Certificate of Appropriateness Amended

926 W. JUNEAU AV. Pabst Brewery Complex Historic District

Description of work The Certificate of Appropriateness for the construction of a new mixed use building on Brewery Block 4, issued on August 11, 2016, is hereby amended to reflect some minor changes made to the Juneau Avenue elevation due to code and various site conditions.

Revised Juneau Avenue (south) Elevation

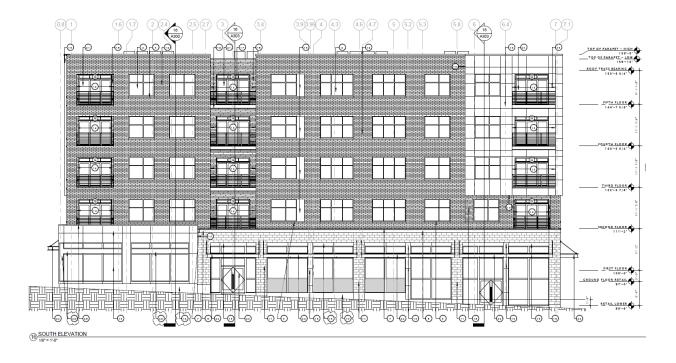
> The entrance as previously approved was recessed below the balcony area. The entrance had to be brought to grade as plans went through the permitting process. The entrance is now in the same plane as the storefronts to the right or east. Some of the storefronts will have tinted spandrel glass at their base to conceal floor levels that are higher than the sloping grade. A drawing of the modifications is attached.

The spandrel glass along Juneau Avenue will be tinted. The entry will be located at grade.
